## STAFF REPORT

### Community Planning and Preservation Commission Certificate of Appropriateness Request

CITY FILE NO.: 20-90200106

Review of a Certificate of Appropriateness for the construction of a residential addition at 2651 3<sup>rd</sup> Ave N, a property proposed for inclusion as a contributing property to a local historic district currently pending public hearing.

# FLOOR PLAN

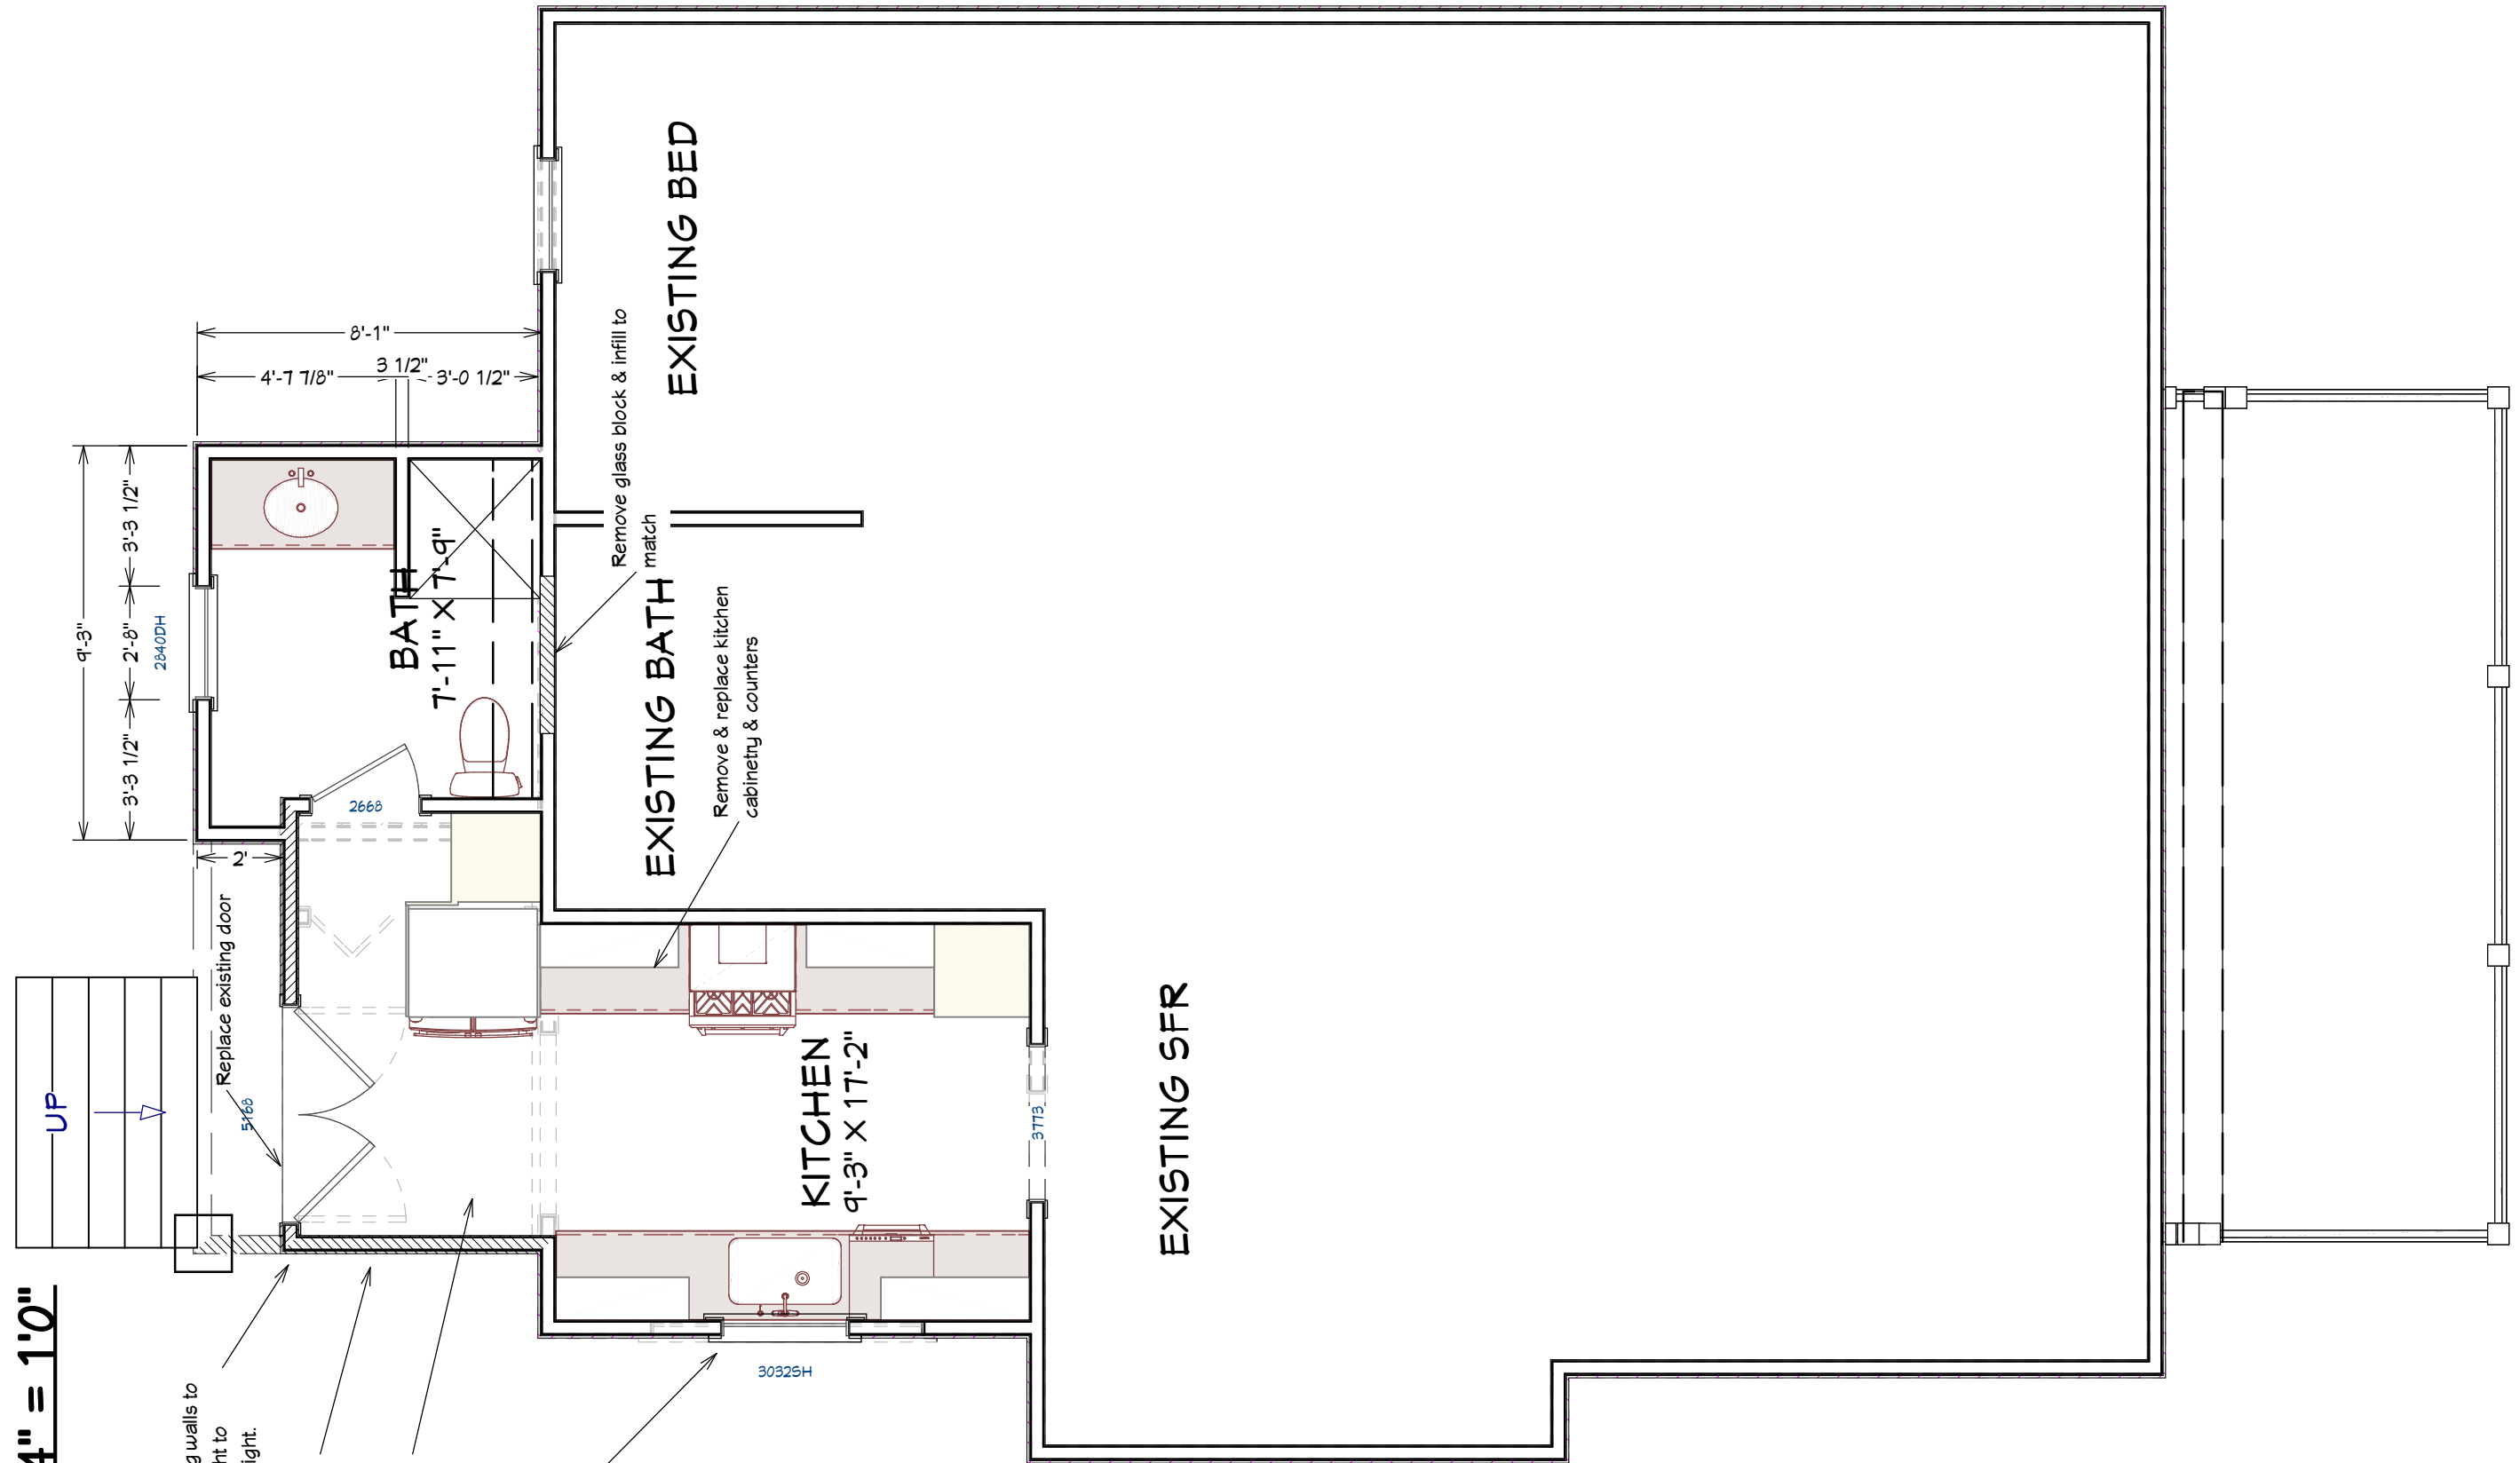
**Consistent** The proposed addition will elongate an existing rear bump-out. The current bump-out is approximately 60 square feet, and the proposed addition will double the size of the rear bump-out and construct a gable roof that is compatible with the main structure. The addition will constitute a slight change in the subject property's overall design, but staff finds the addition to be sensitively-applied and appropriately located in the rear of the structure.

**Consistent** The materials to be removed will be at rear elevations and will not be visible. The proposed addition will be compatible with the main house in terms of massing, size, scale, and will utilize similar architectural features.

**Rear Elevation**

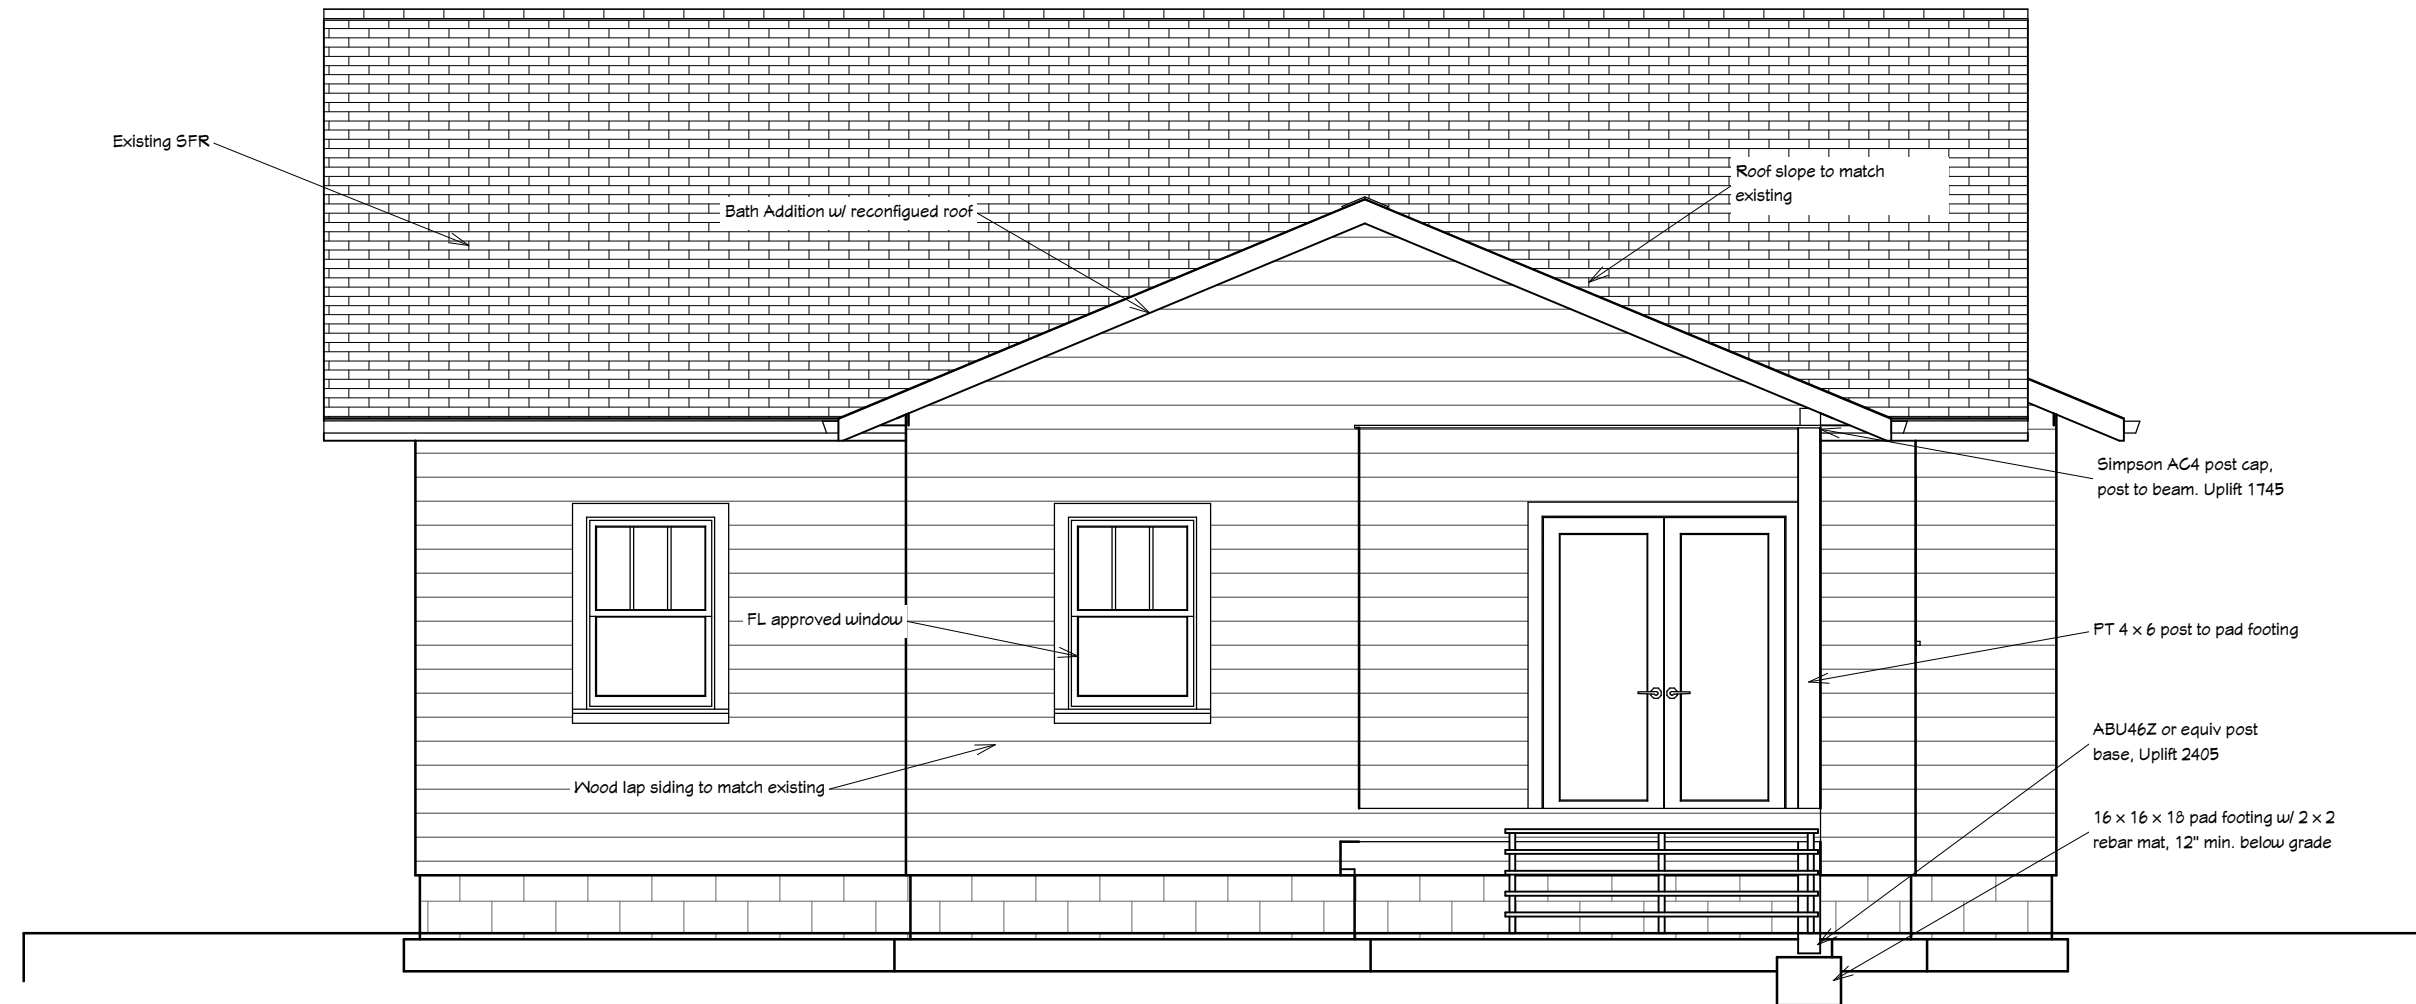
**Figure 2: Proposed rear elevation with new gabled roof addition.**

**Consistent** The proposed addition will utilize a front gabled roof that will be lower than the main house's roof. This is in keeping with other resources in the district.

**Consistent** The proposed addition will be located on the rear, and will only extend the rear bump-out portion of the house east by 7 feet, 9 inches. This will be visually compatible with other contributing resources in the proposed district.

**Consistent** The proposed gabled roof will match the pitch of the existing roof, but will be lower. This roof form is typical to many resources in the proposed district.

1. Windows will be installed to be setback within the wall plane and feature a reveal of approximately two to three inches to provide consistency with the historic windows at subject property.
2. Proposed windows will feature contoured, three-dimensional external muntins that replicate traditional muntin design.
3. All other necessary permits shall be obtained. Any additional work shall be presented to staff for determination of the necessity of additional COA approval.
